Technical Service Bulletin: TSB110218

Improved Water Transfer Connection

Figure 1: New End Cap

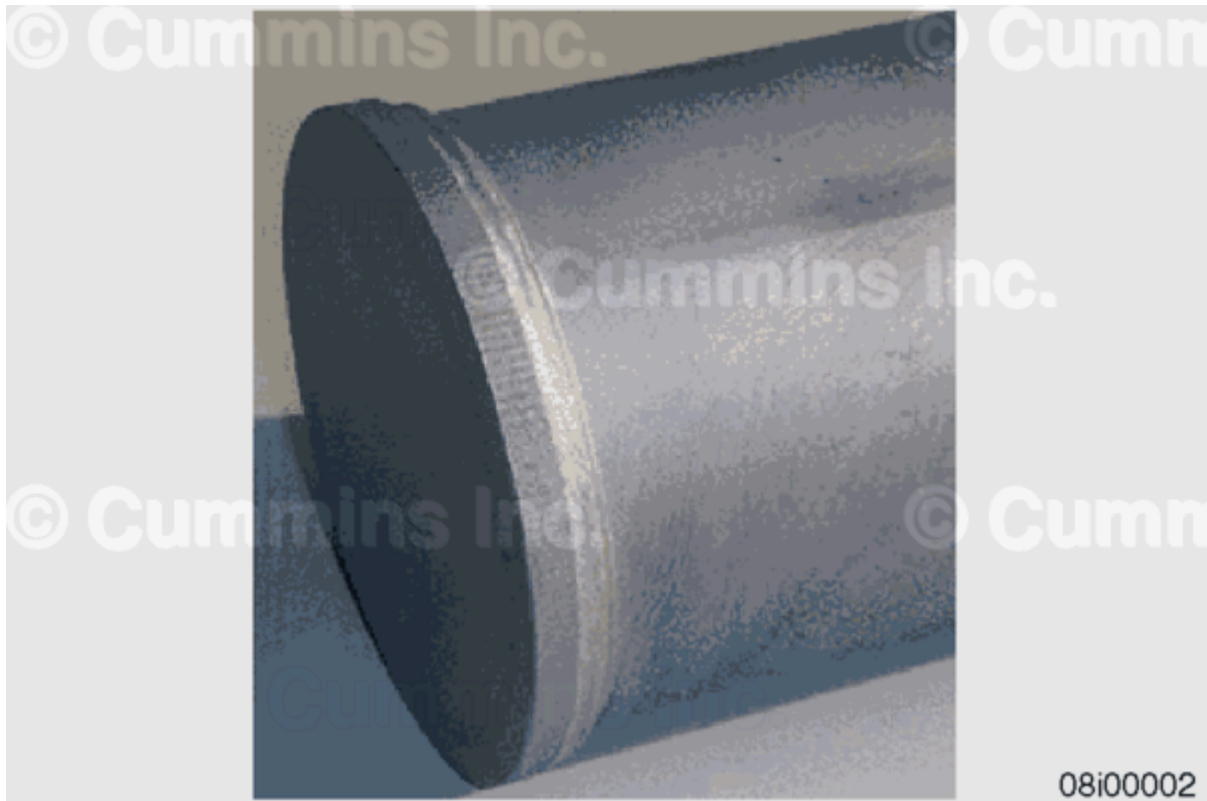
This document introduces a new water transfer connection for the K19 and QSK19 engines. The new water transfer tube, Part Number 5288358, obsoletes and supersedes the old tube, Part Number 3008862. The new tube has an improved cap design for increased durability. The new design has a cap that is fillet welded for more consistent manufacturing. See Figure 1.
